Director's Report

Project Name: Redevelopment at 9328 Highland
 Description: Preliminary Site Plan Approval
 Date on Agenda this packet pertains to: August 5th, 2021

RE: 9328 Highland Road- Commercial Building with Drive Thru- Preliminary Site Plan Review – 1st Review

Subject: 9328 Highland Road
Preliminary Site Plan Review
Zoned: General Business (GB) District

DRAWING: **C-5**

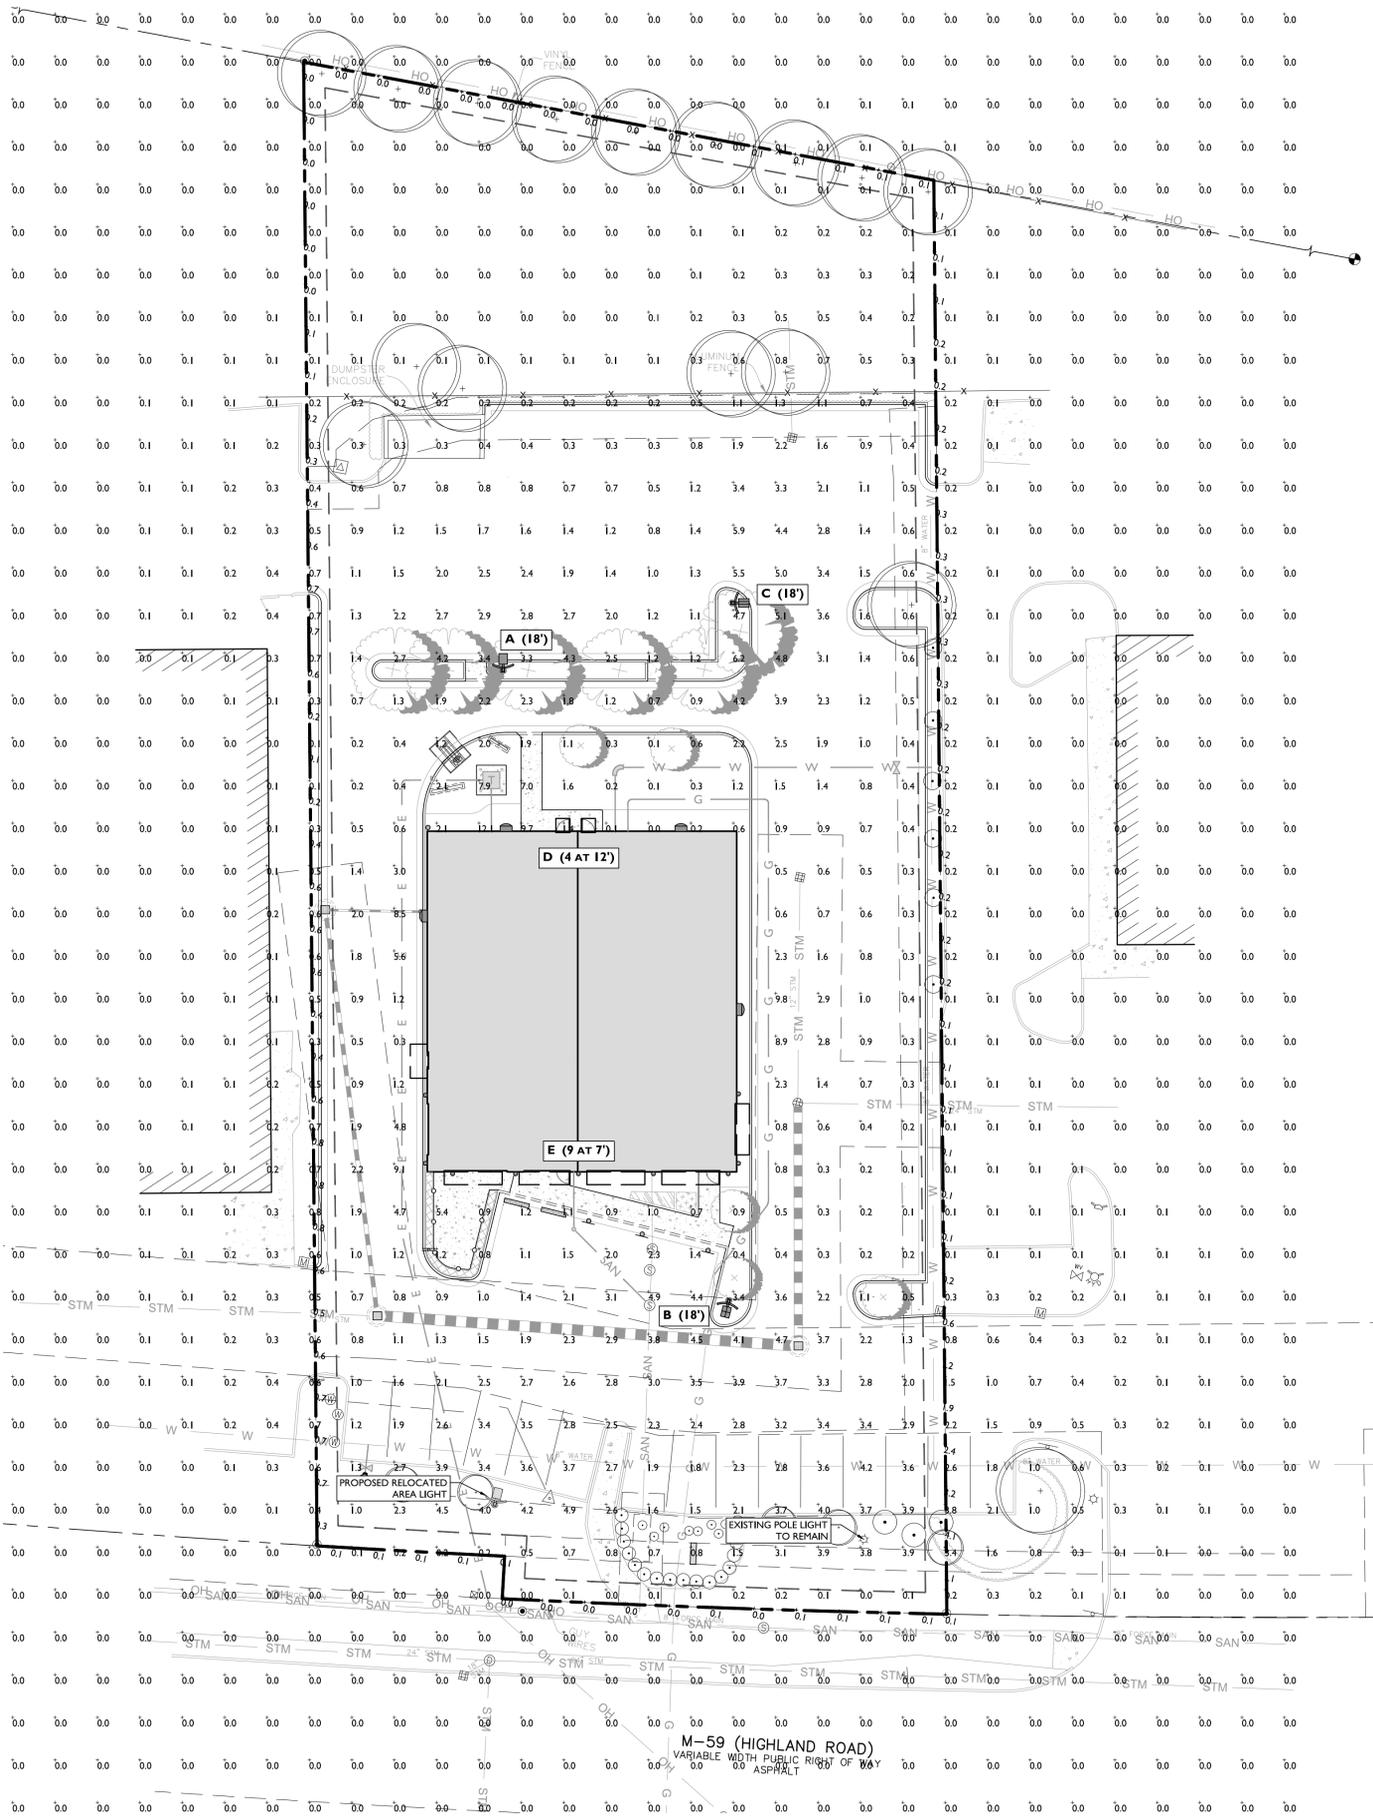
1. A separate connection for a sanitary sewer lead is proposed for the drive-thru restaurant. It needs to be clarified that all kitchen discharge lines are routed to the existing external grease trap. Please also clarify if existing oil and grease separator is properly sized for the new use.

2. The existing watermain easement, where the hydrant and watermain is proposed to be removed, will need to be vacated.
 3. The existing storm sewer easements, where the existing storm sewer is to be removed, will need to be vacated.

10. The proposed storm sewer easement on the westernmost storm segment is shown over the subject property line, will this easement be granted by the adjacent property owner?

DRAWING: C-6

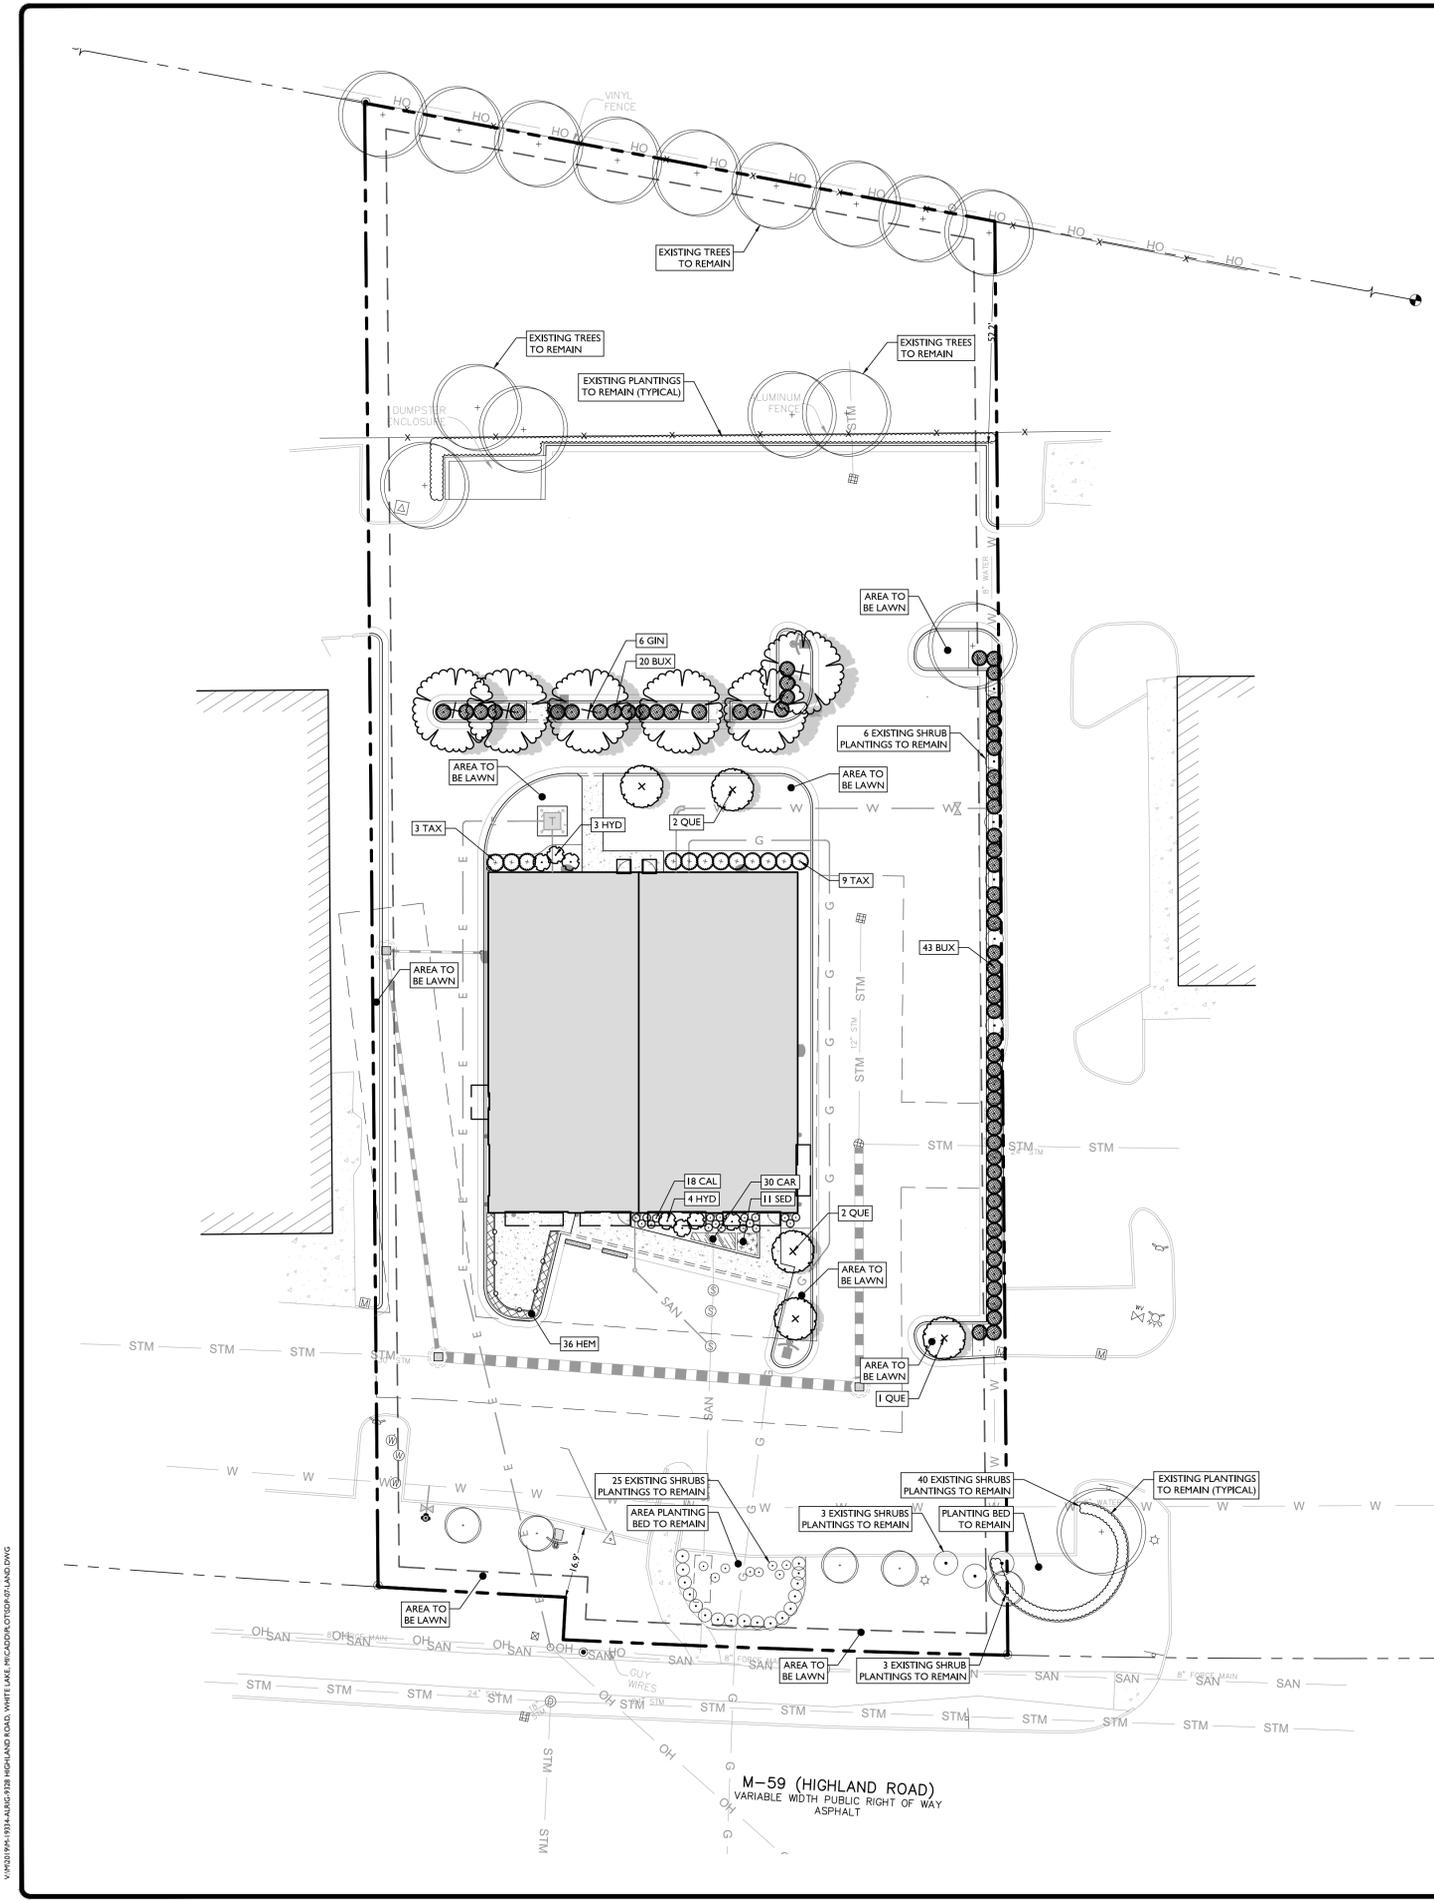
7. **Lighting.** Section 5.18(G) of the Zoning Ordinance includes the standards for outdoor lighting. A photometric plan was submitted. The plan states that the maximum foot candles at the property line exceed the permitted maximum of 1-foot candle and a notation that this is an existing light level. **The Planning Commission should determine whether or not this level of light is acceptable because it is existing.** The highest light levels occur along the front lot line by an existing pole light and a (proposed) relocated area light. If any existing fixtures are relocated or replaced, they should be brought into compliance with ordinance standards,.

Nine, rubbed bronze anodized sconce fixtures are proposed on the building. Article 6, Section 6.8.E.vii of the Zoning Ordinance states *floodlights, wall pack units, and other types of unshielded lights, and lights where the lens or bulb is visible outside of the light fixture are not permitted.* The intent is wall-mounted decorative or architectural lighting must be fully shielded and directed downward – up-lighting or outward shining lighting are not permitted. **The petitioner should revise the proposed light fixtures with those that meet the Ordinance requirements.** Four wall packs are proposed; two on the rear elevation and one on each side elevation. These wall packs are in compliance with the Ordinance as they are directed downward.

11. The petitioner should revise the proposed (wall sconce) light fixtures with those that meet the Ordinance requirements.
12. The applicant to provide detail on the wall sign calculations with respect to the front façade area and the area of the proposed wall signs.

DRAWING: **C-7**

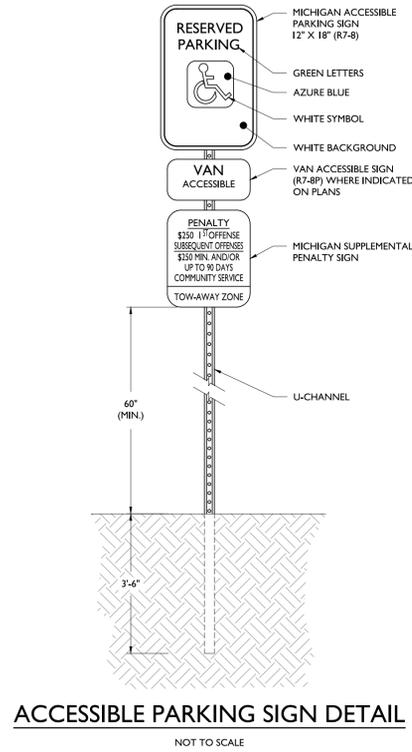
A greenbelt is required on the west and east side lot lines. A four-foot-wide landscaped area (with boxwood shrubs) is proposed on the east lot line. No buffer is proposed on the west, although there is an existing shrub buffer on the Discount Tire site at this shared property line. Again, the applicant's plan states that this is an existing nonconformity. **The Planning Commission should determine if this is appropriate and give direction to the applicant.** Typically, landscape plans are not required at preliminary site plan review, therefore, any direction should be incorporated into the final site plan review landscape plan.

Three notes should be added to the landscape plan:

- A note guaranteeing a two-year guarantee and bond for such for all new plant materials; and
- A note that all landscaped areas that abut parking areas will be separated with a 6-inch curb; and
- A note that any landscaping materials that are in poor condition will be removed and replaced with materials that meet the Zoning Ordinance requirements

SHEET NAME:
 PRELIMINARY FLOOR PLAN
 AND EXTERIOR ELEVATIONS

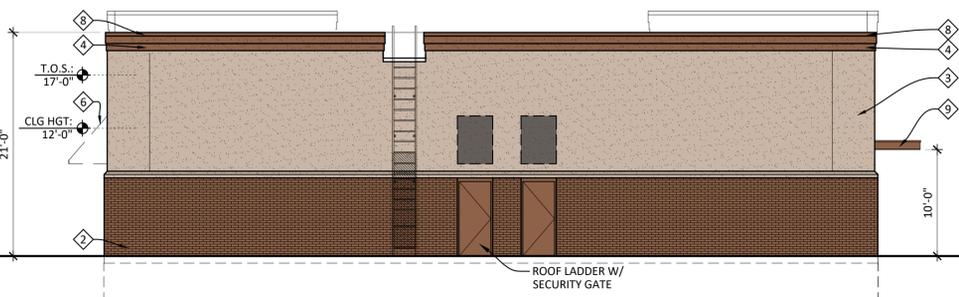
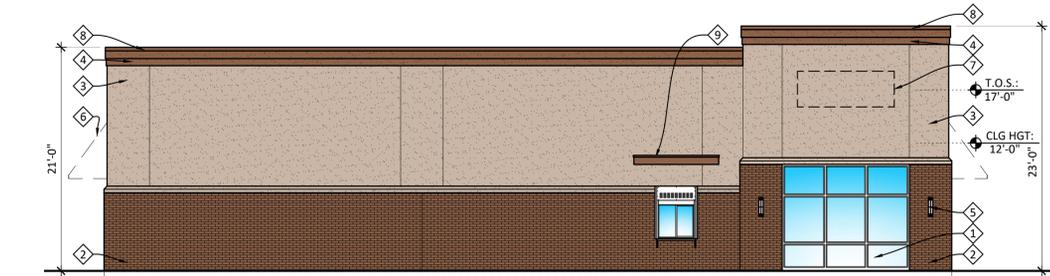
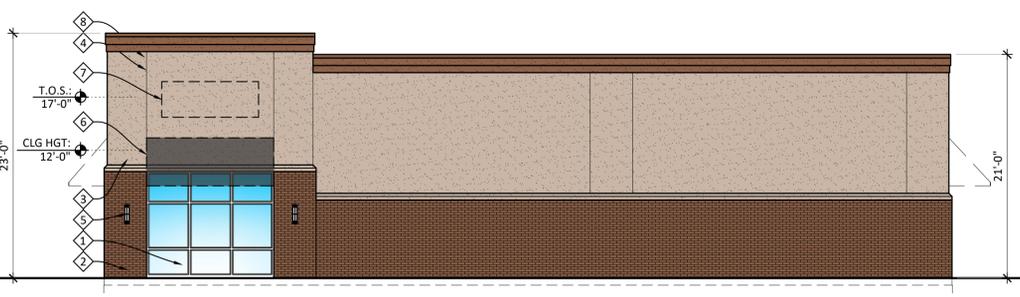
The building consists of brick veneer on the lower (approximately) one-third of the building, EIFS on the upper two thirds of the building, a prefinished metal coping along the top of the building and windows along the front and on the west and east elevations for approximately 19 feet. A narrow band of EIFS in a contrasting color is also shown just below the metal coping. Four fabric awnings are proposed along each bay of windows and a sign area has been identified above the western most and eastern most bay of windows. Article 6, Section 8.E requires all nonresidential developments adjacent to M-59 to consist of primarily high quality, durable, low maintenance material, such as masonry, stone, brick, glass or equivalent materials. **The applicant needs to provide calculations for the amount of the façade that meets this requirement(at least 50%, preferably 70%) as well as the percentage of windows on the front façade (required to be at least 30%).**

1. Specifications on the number of tables and chairs to be made a part of the final site plan.
2. The applicant needs to provide calculations for the amount of the façade that meets the Zoning Ordinance requirements as well as the percentage of windows on the front façade (required to be at least 30%).

TRASH ENCLOSURE DETAIL

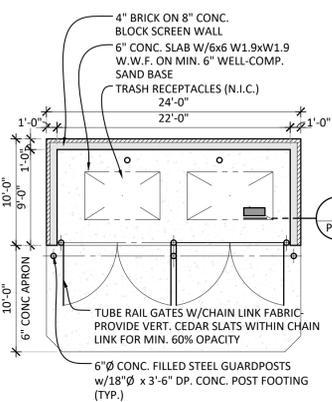
9. **Trash Disposal.** The applicant is proposing to utilize the existing 9-foot by 22-foot trash enclosure. The enclosure consists of brick veneer on a concrete block screen wall on a 6-inch concrete slab. The enclosure gate is chain link gate fabric with cedar slats. The Zoning Ordinance requires *dumpster enclosures to be constructed of the same decorative masonry materials as the buildings to which they are accessory.* The enclosure is brick veneer; however, the brick is not the same as the brick on the building. **The Planning Commission should determine if this is appropriate, as it is existing.**

MONUMENT SIGN

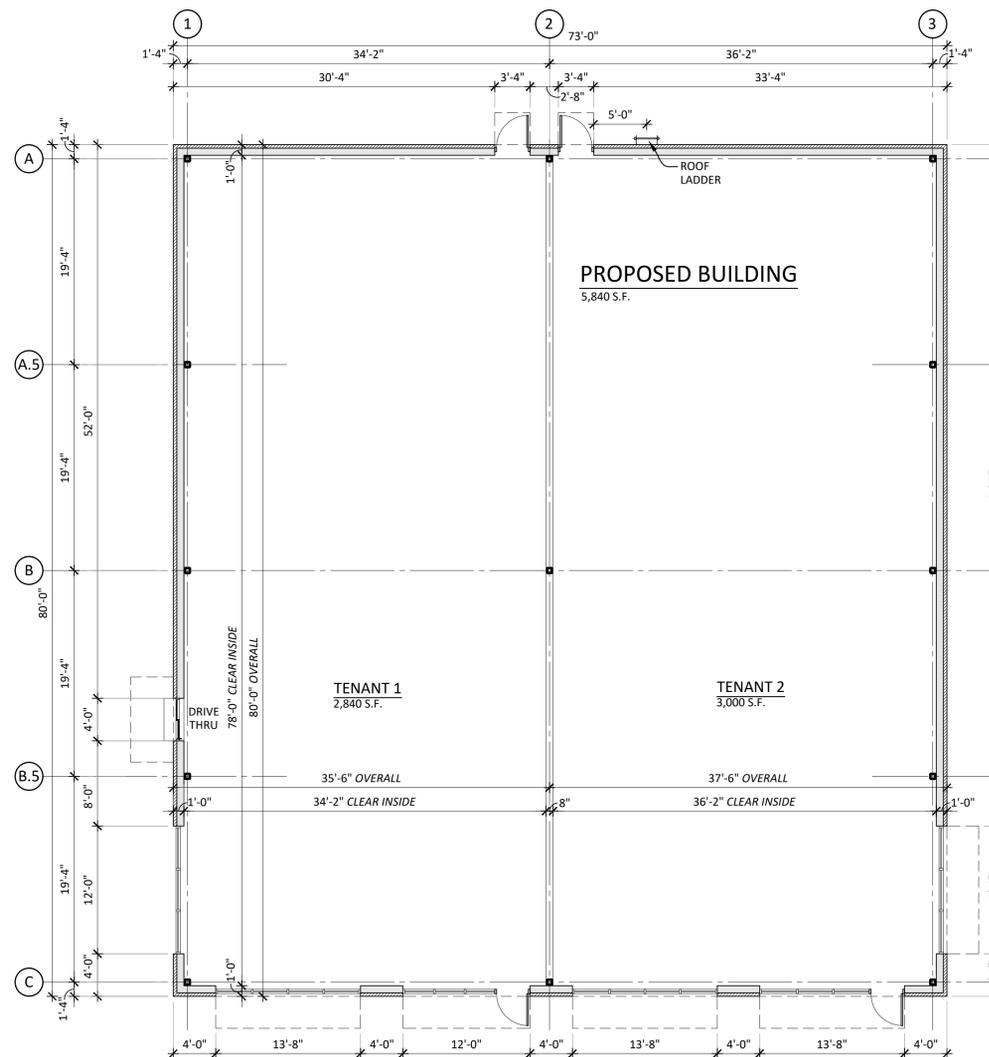
8. **Signs.** Section 5.9 of the Zoning Ordinance regulates signs. The site plan indicates one monument style sign along the Highland Road frontage. The sign is 7'-6" in overall height and 5' wide. The base consists of brick veneer to match the building with a stone cap. The size of the actual sign area is 27.5 square feet per side, which is in compliance with the Zoning Ordinance.

The Zoning Ordinance permits two wall signs for this development. If a parcel has in excess of 250 feet of frontage, an additional wall sign may be permitted. Additionally, if a building has frontage on two thoroughfares, they can have additional signage. This parcel has 148 feet of frontage and does not have frontage on any thoroughfare other than Highland Road. The two side elevation wall signs are not permitted. **At final site plan review the applicant should provide detail on the wall sign calculations with respect to the front façade area and the area of the proposed wall signs. Lastly, the monument sign must have the address of the businesses on it in 6-inch high figures.**

13. Address of the businesses being added to the monument sign in letters at least 6 inches in height,
14. Determination by the Planning Commission as to the utilization of the existing trash dumpster enclosure.
